# CPED STAFF REPORT

CPC Agenda Item #8  
September 29, 2014  
BZZ-6765

**Property Location:** 428 South 2<sup>nd</sup> Street  
**Project Name:** Mill City Quarter Phase 2  
**Prepared By:** [Janelle Widmeier](#), Senior City Planner, (612) 673-3156  
**Applicant:** Ecumen  
**Project Contact:** Gretchen Camp, BKV Group Inc.  
**Request:** To allow a new 5-story assisted living facility.  
**Required Applications:**

**EXTERIOR  
ELEVATIONS -  
RENDERED**

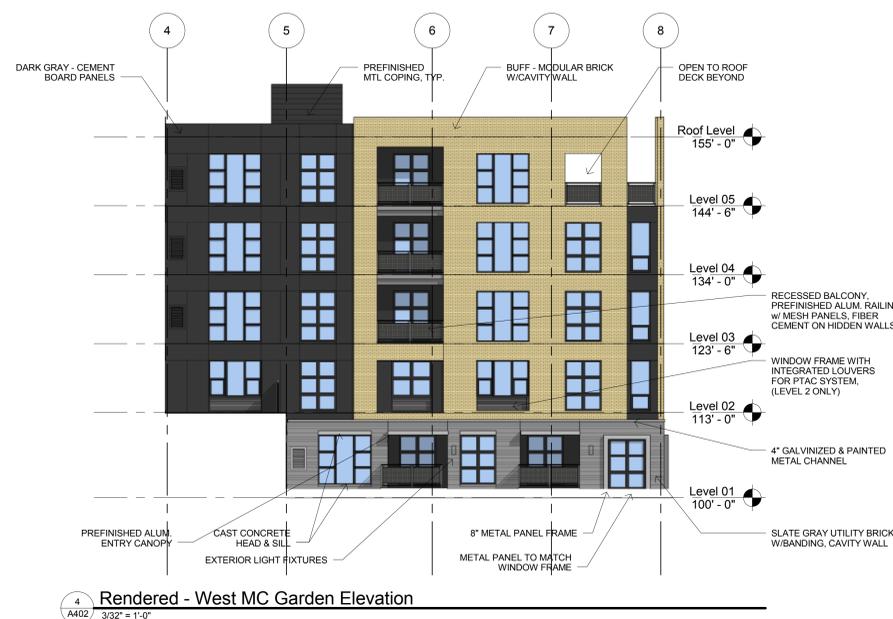
- Blank, uninterrupted walls that do not include windows, entries, recesses or projections, or other architectural elements would not exceed 25 feet in length, except on the first floor north building elevation. Alternative compliance is requested.

1. Additional architectural elements shall be provided on the first floor wall of the north building elevation to prevent a blank, uninterrupted wall that does not include windows, entries, recesses or projections, or other architectural elements more than 25 feet in length as required by section 530.120 of the zoning code.
2. Bicycle parking shall be provided for the nonresidential use as required by section 541.180 of the zoning code.
3. Department of Community Planning and Economic Development staff review and approval of the final building elevations, floor, site, lighting and landscape plans.
4. Site improvements required by Chapter 530 or by the City Planning Commission shall be completed by September 29, 2016, unless extended by the Zoning Administrator, or the permit may be revoked for non-compliance.
